From: Philip Barrett
Sent: 18 Oct 2019 16:42:51 +1300
To: Cameron Aplin
Subject: Singleton Subdivision Revised Flood report
Attachments: S92 Amended Final Report-August2019- Culvert flooding scenario.pdf, M13246 Scheme Plan 18.10.2019.pdf

FLOODPLAIN ANALYSIS

635 Whatawhata Road, Hamilton

Proposed Subdivision of Lots 1 & 2 DPS 12627
635 Whatawhata Road, Dinsdale.

Figure 5.1 – Hydraulic grade-line comparing a 50% blockage

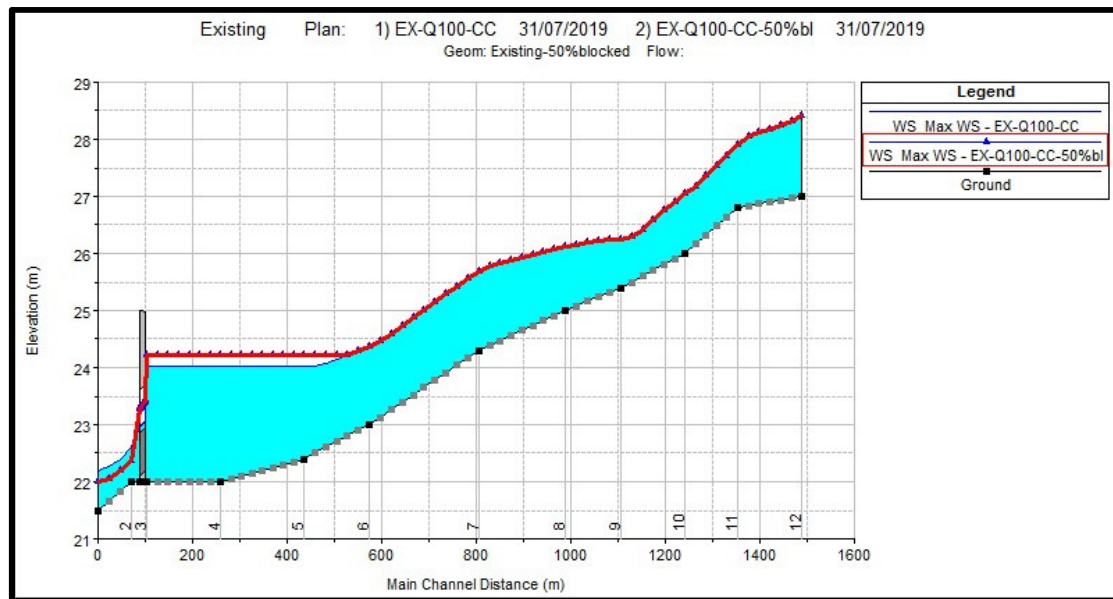
3(b) above - Specifically we need to understand the flooding effect of the culvert under the road being blocked, however unlikely, on the proposed building platforms. What would the wastewater field levels look like now and any change should the culvert block. I have attached the latest signed plans that show RL levels of building platforms suggested in your report to be confirmed. Please review and revise your report.

The hydraulic model was re-run with the 100-year storm and the bottom 0.75m of the culvert blocked.

Figure 5.1 shows the hydraulic profiles along the reach comparing the non-blocked and 50% blocked. The 50% blockage effects cross-sections up to RS6. The increase in water level at the culvert is 0.2m. The flow is decreased from $4.1\text{m}^3/\text{s}$ to $1.6\text{m}^3/\text{s}$.an almost 61% capacity loss.
